Addendum No.: 1

Date Of Addendum: 12 March 2019

CT DAS | Construction Services | Office of Legal Affairs, Policy, and Procurement
Department of Motor Vehicles
Hamden Roof and HVAC
1985 State Street
Hamden, CT
BI – MM-54

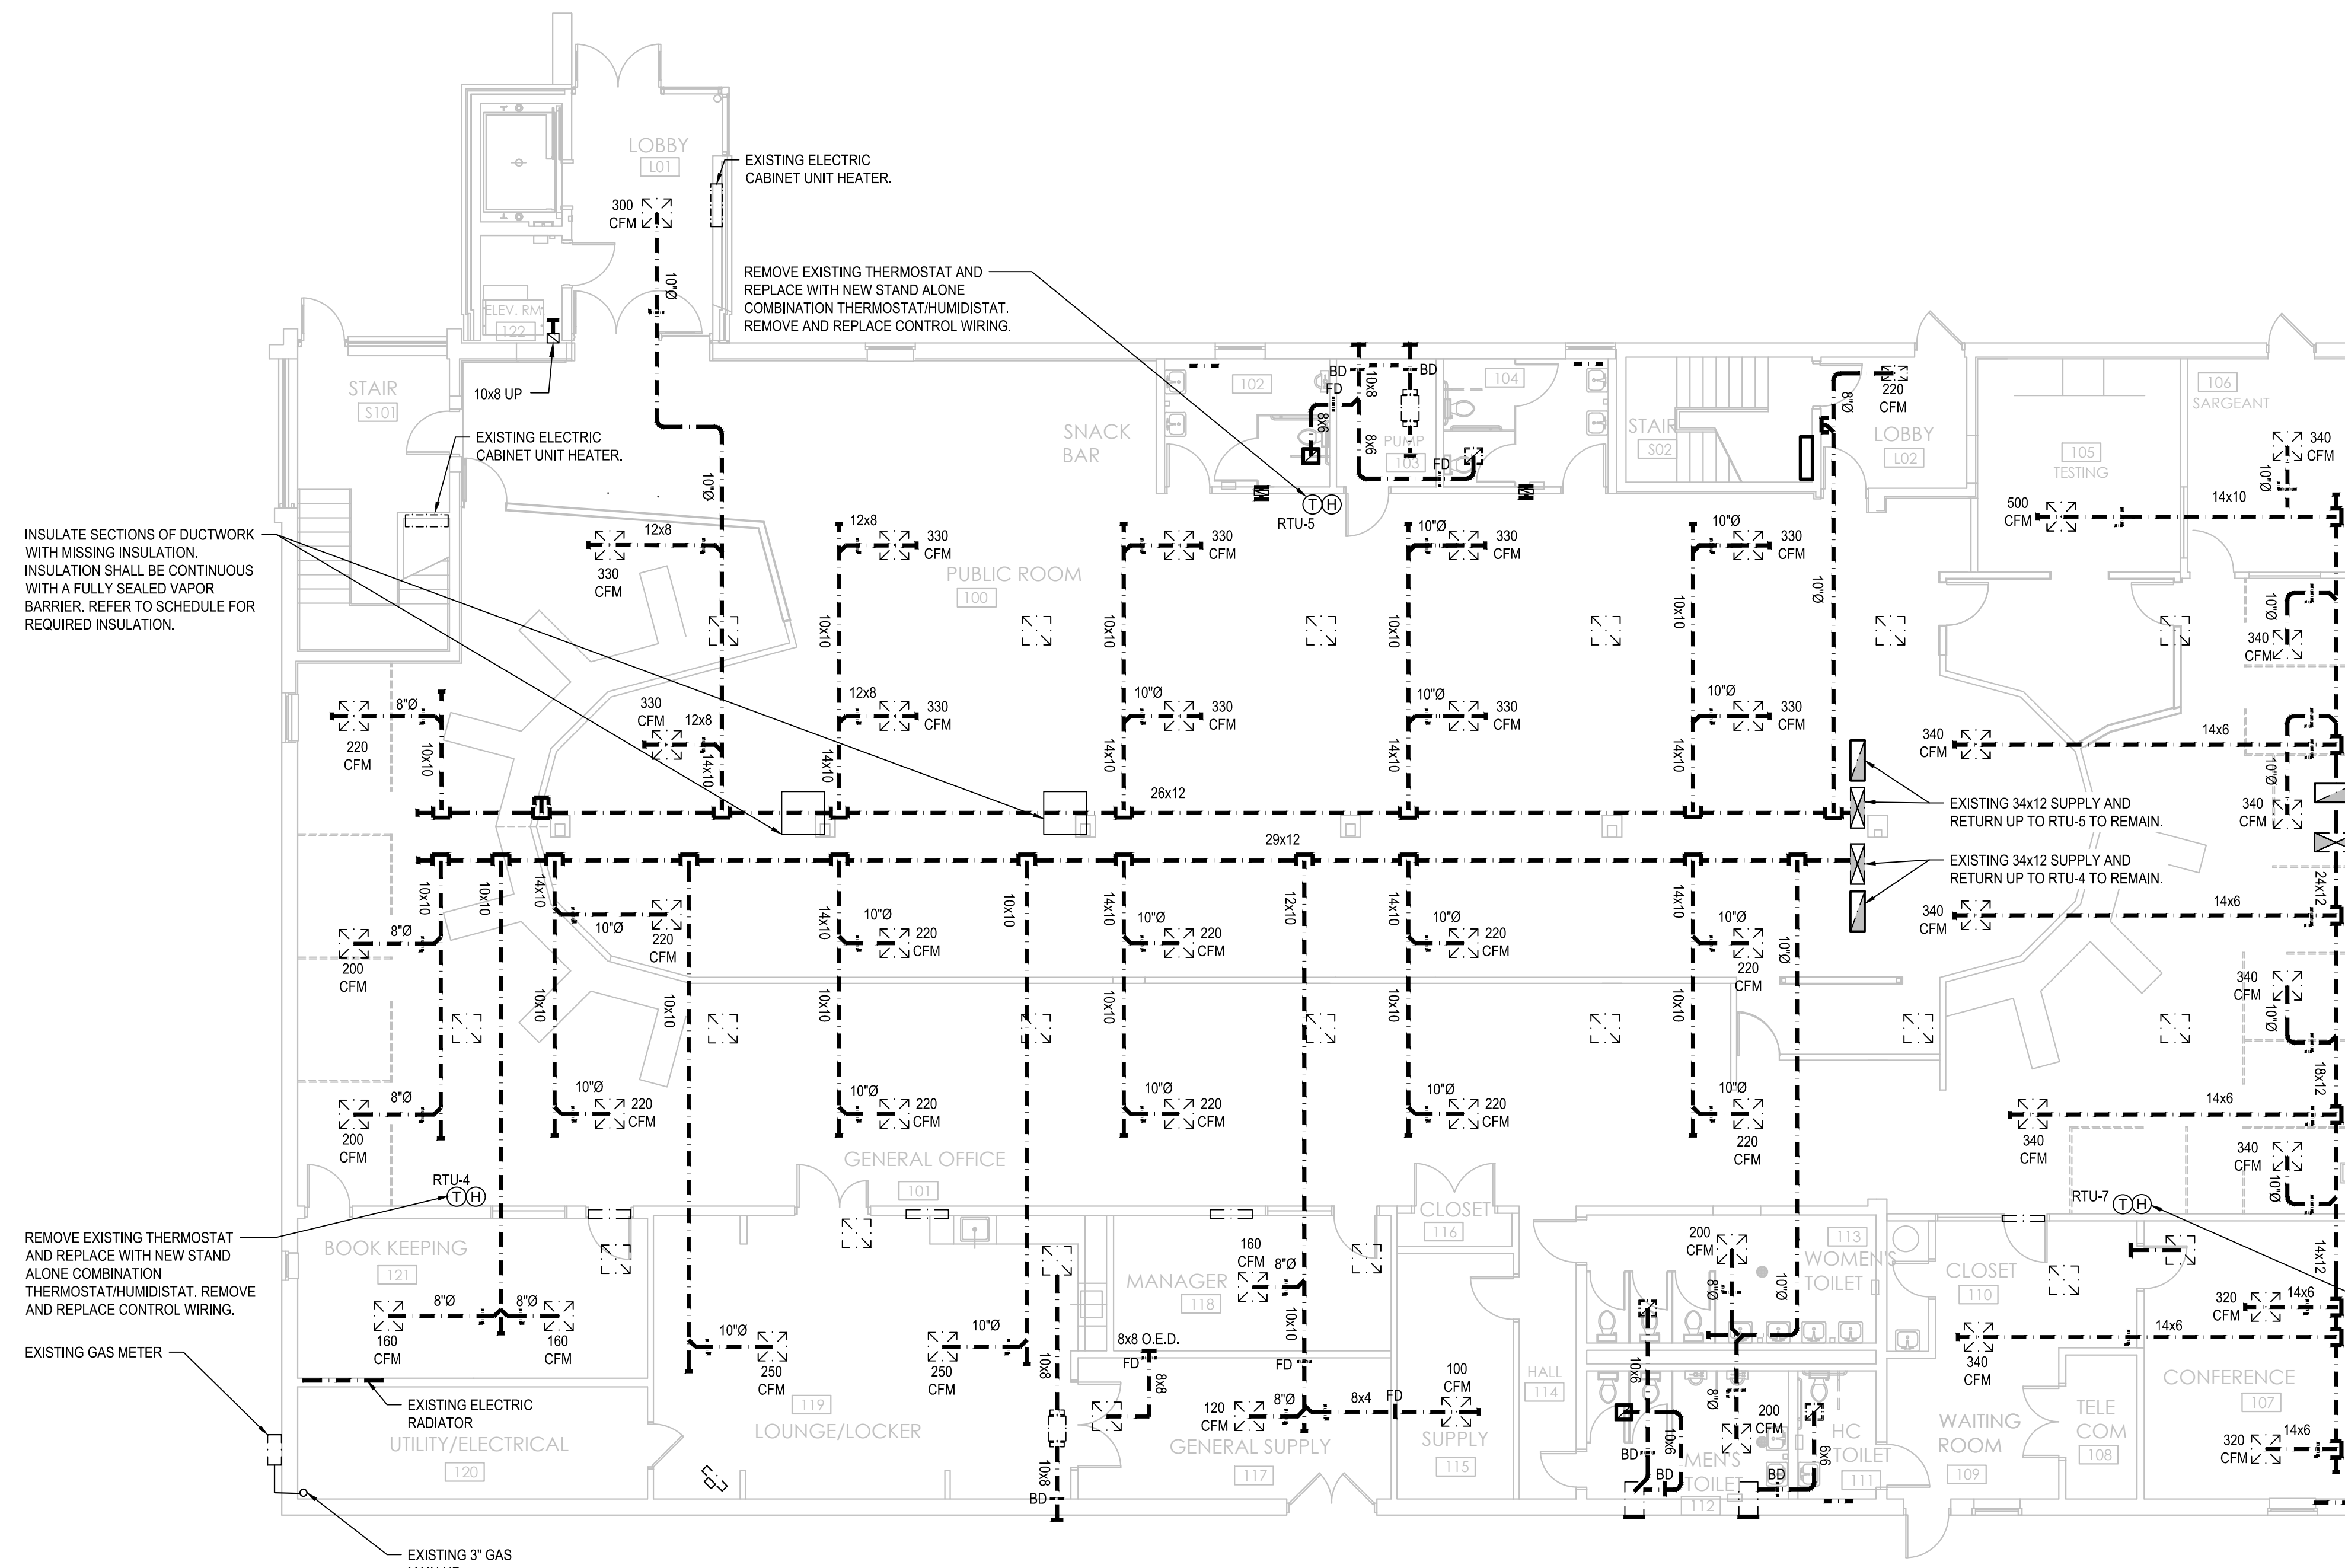
In Drawing M-001 Cover Sheet - Mechanical:

REVISION: “Modify General Mechanical Symbols” to include “Existing Volume Damper to Remain” and “Existing Shutoff Valve to Remain”

SUBSTITUTE: Drawing M-001, dated 03/04/19 Addendum 1

2 FIRST FLOOR ZONING PLAN
M-101 Scale: NOT TO SCALE

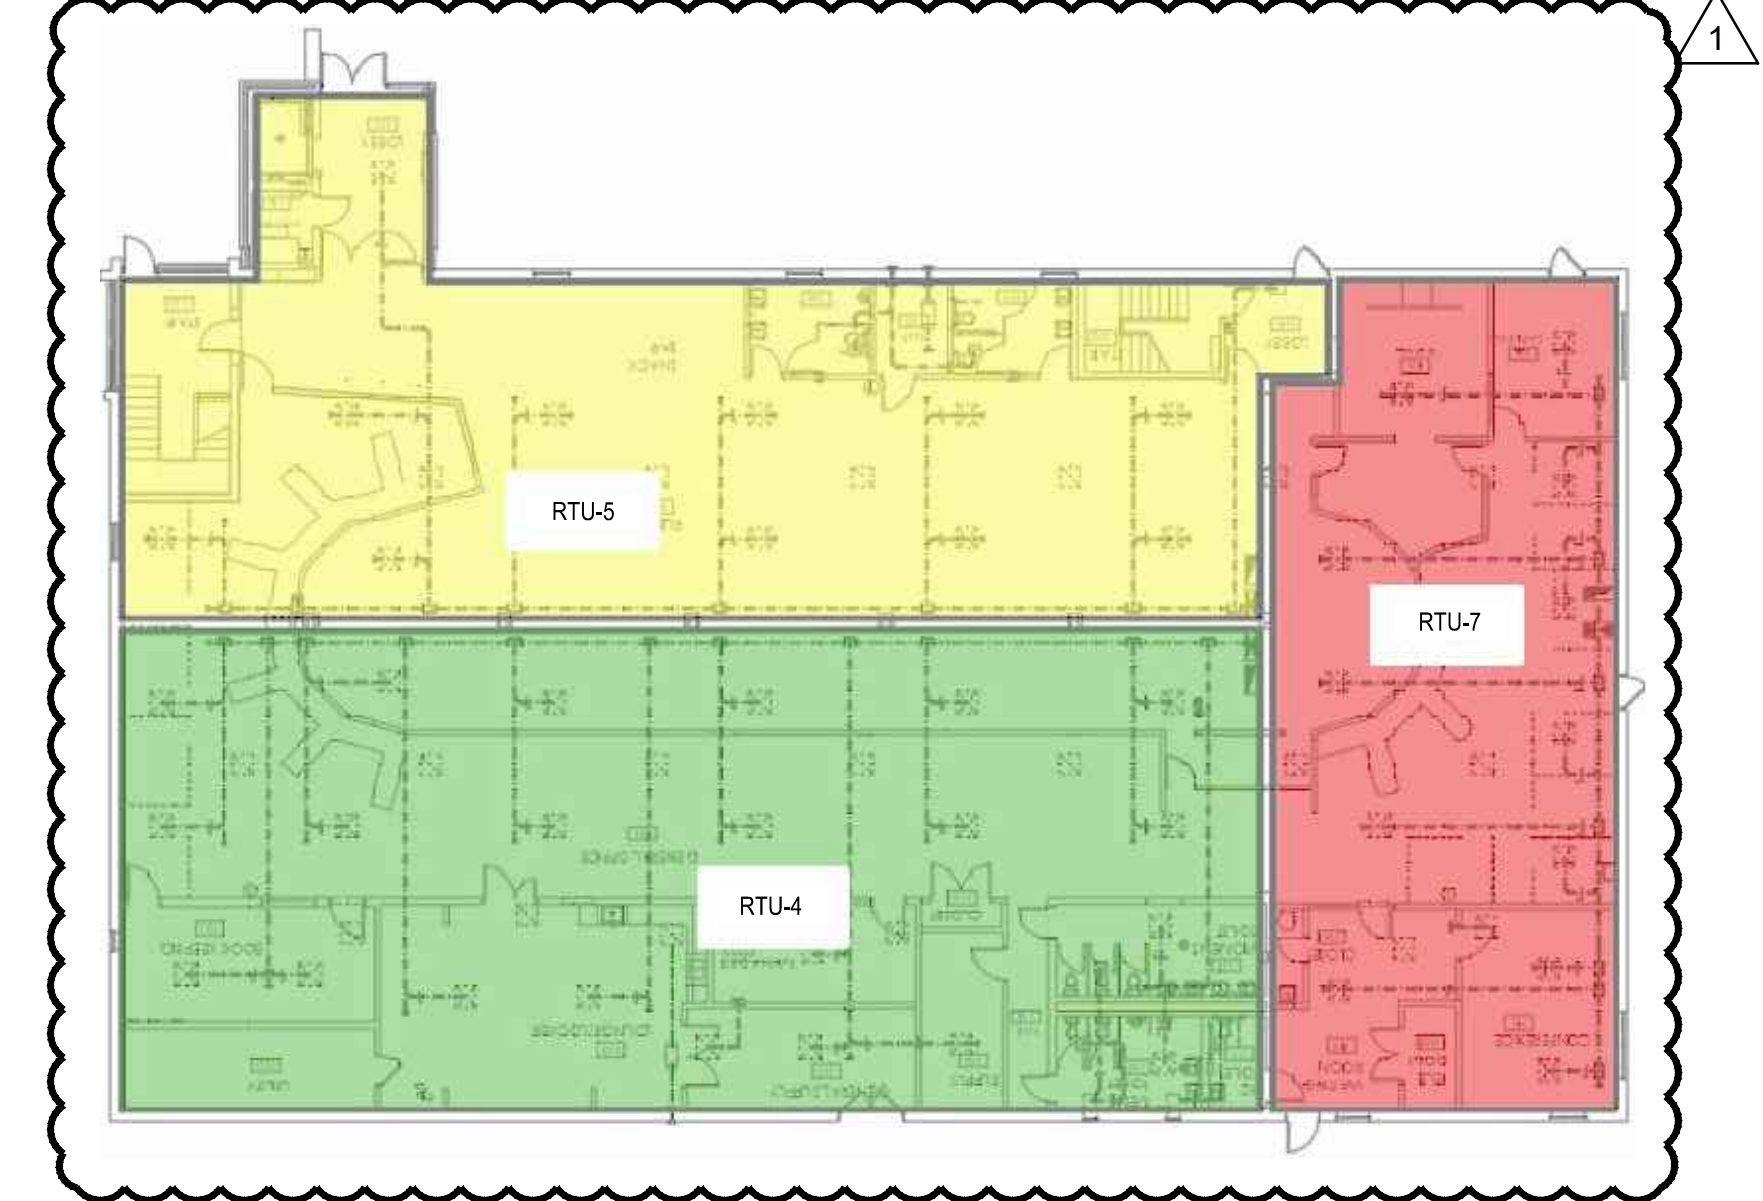
In Drawing M-101 First Floor Plan - Mechanical:

REVISION: Modify orientation of Detail 2/M101 First Floor Zoning Plan

SUBSTITUTE: Drawing M-101, dated 03/04/19 Addendum 1

2 SECOND FLOOR ZONING PLAN
M-102 Scale: NOT TO SCALE

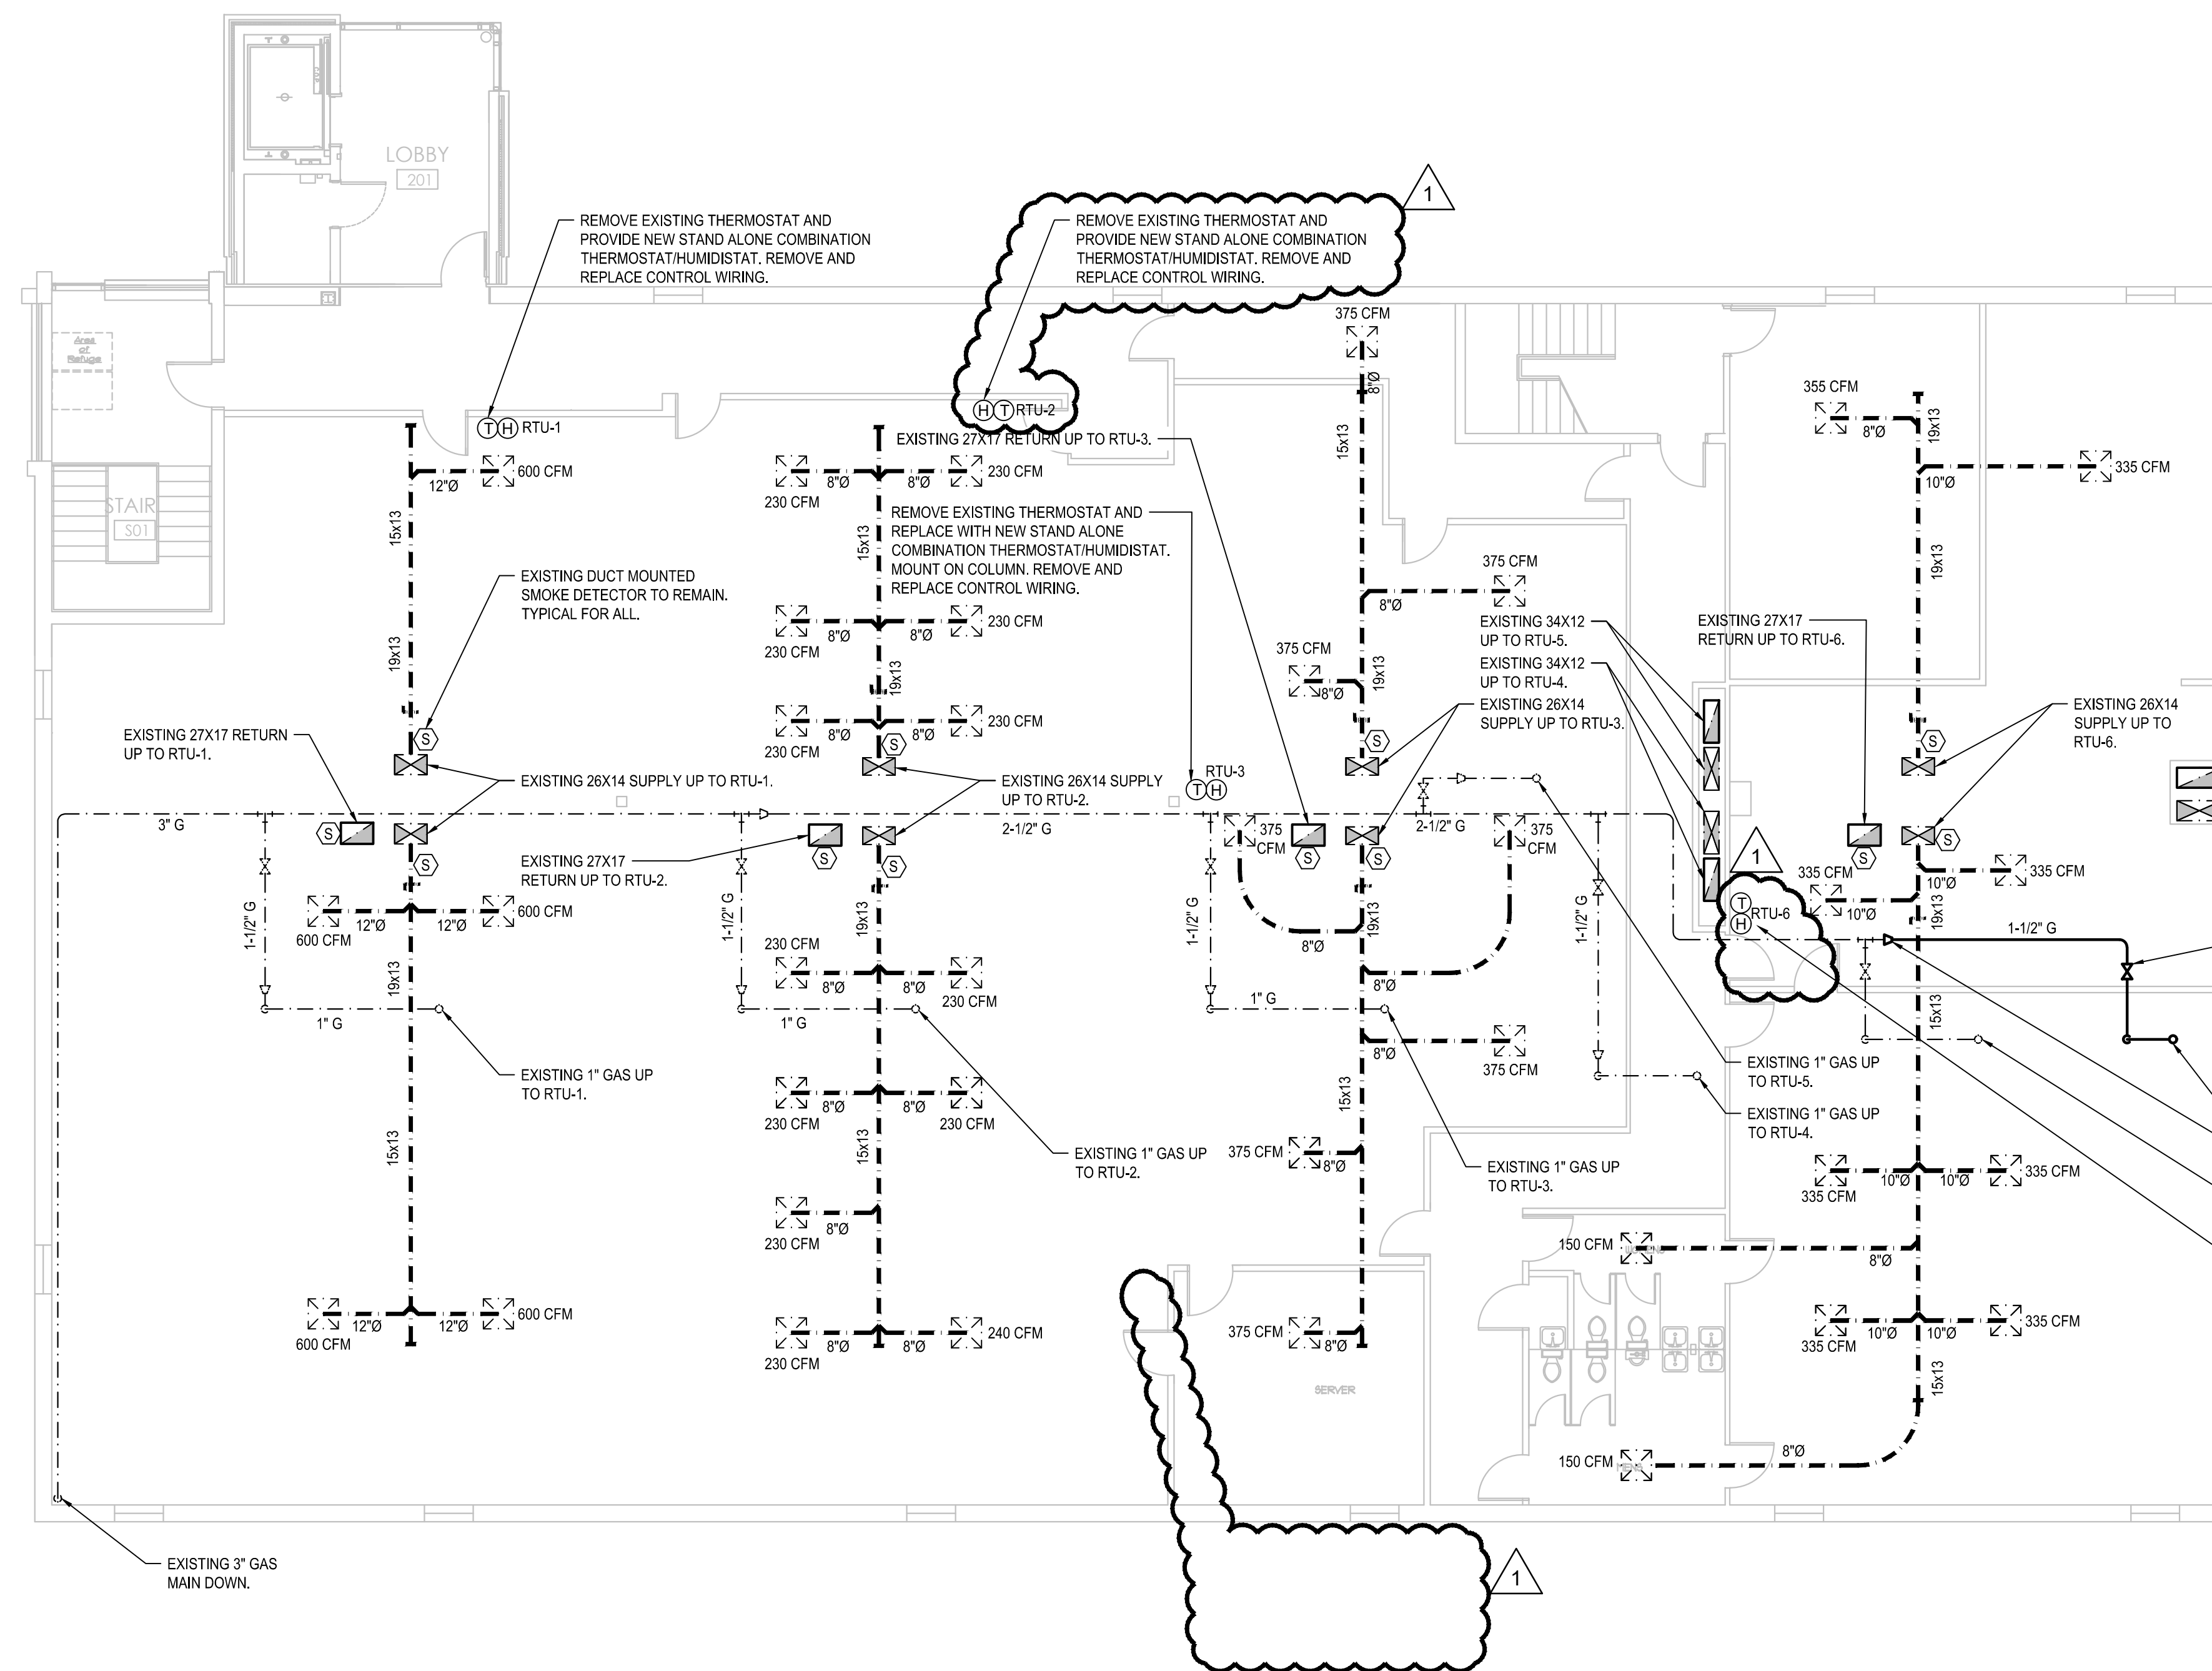
In Drawing M-102 Second Floor Plan - Mechanical:

REVISION: Modify orientation of Detail 2/M102 Second Floor Zoning Plan and modify location and scope of work related to existing thermostats.

SUBSTITUTE: Drawing M-102, dated 03/04/19 Addendum 1
